DESIG	A	DRAWN BY	DART AEROSPACE LTD HAWKESBURY, ONTARIO, CANADA	
CHEC	KED M	APPROVED	DRAWING NO.	REV. A
	#	All	DSI 9261 SHEET	1 OF 1
DATE			TITLE	SCALE
03.0	03.05.13		KWIK FLOAT INSTALL MODIFICATION	1:2
Α		03.05.13	NEW ISSUE

DART SERVICE INSTRUCTION

TO AMEND BHA-DRA-358-11 SHEET 1, REV. D AND IIN-D206-590 REV. NI

<u>TYPICAL 358-011-001 / 358-012-001 CLAMP (SHOWN)</u> 358-011-002 / 358-012-002 CLAMP (OPPOSITE)

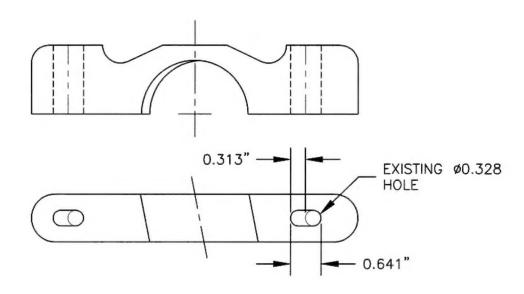
TO IMPROVE THE FIT OF THE SPONSON ASSEMBLIES ON THE LANDING GEAR, IT IS ACCEPTABLE TO ELONGATE THE SLOTS IN THE 358-011-001/-002 & 358-012-001/-002 CLAMPS BY UP TO 0.313" AS SHOWN BELOW:
